Memo

Rev 02 August 13, 2026

Subject: Beach Haven BESS Third Party Risk Assessment Memo
315 2nd Street, Beach Haven, New Jersey 08008

Figure 5. Cover page of the Civil Engineering Calculation

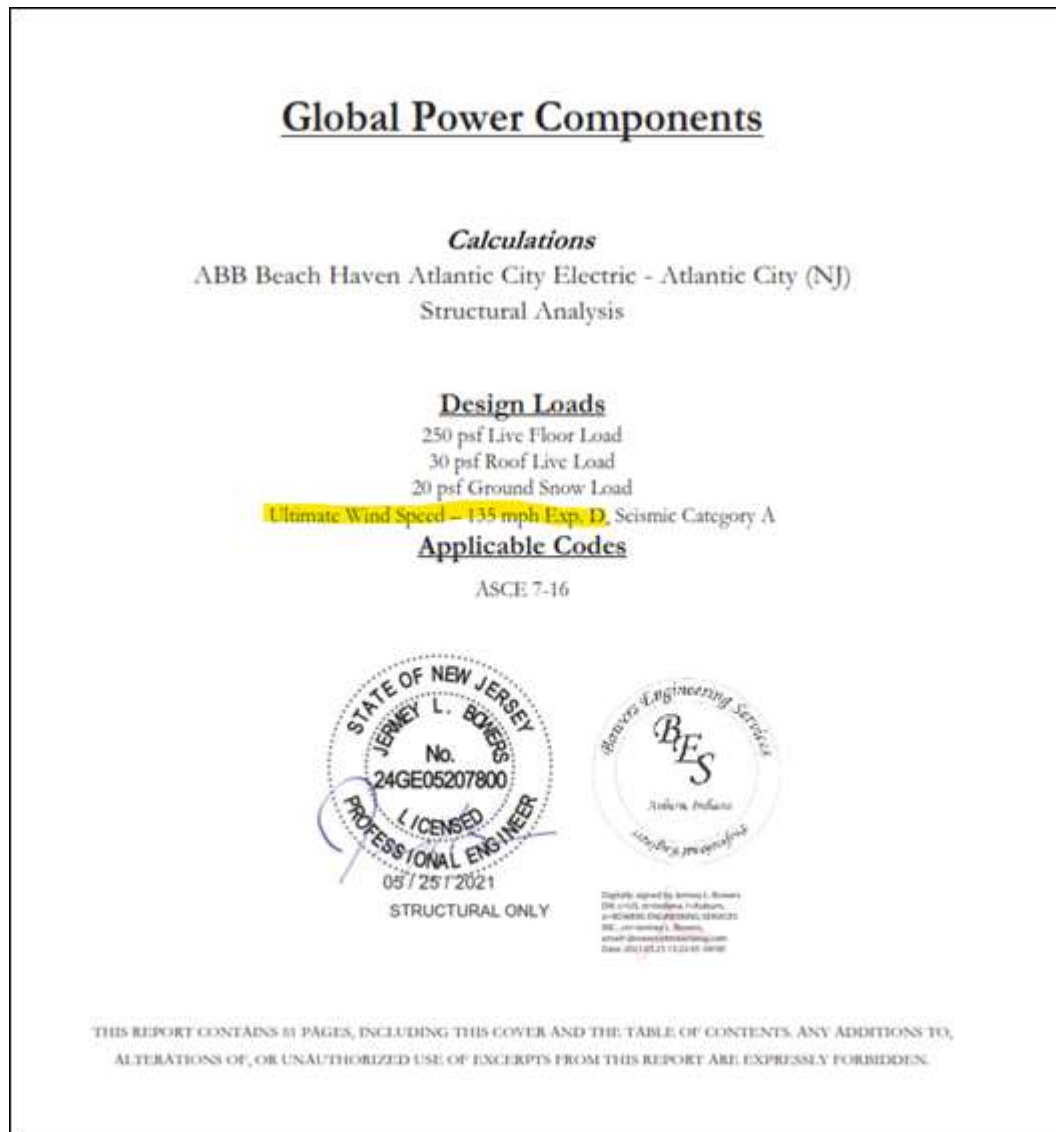
***3/10 UPDATE:** Recommendation #7 has been partially addressed. Available structural documentation, design considerations for structural loading (e.g., ASCE 7-16), anchorage, and lateral stability under flood and wave loading conditions were provided as described in the "Structural Analysis Calculations" and*

Geotechnical Report" furnished by ACE for review in person. Field Evaluated Product Label has been observed to be applied in the field, as corrective actions have been taken as per the "Field Evaluation Services Final Report". Emergency response procedures are described in the "Pre-Fire Plan (PFP)" and "Emergency Operation Plan (EOP)". Specific documentation addressing environmental response actions/spill containment/runoff management was not identified in the material reviewed.

8/13 UPDATE: ACE stated that the enclosure was designed using a 135 mph design basis wind speed and incorporates weather-resistant construction features consistent with NEMA 3R and IP55-rated enclosure characteristics.
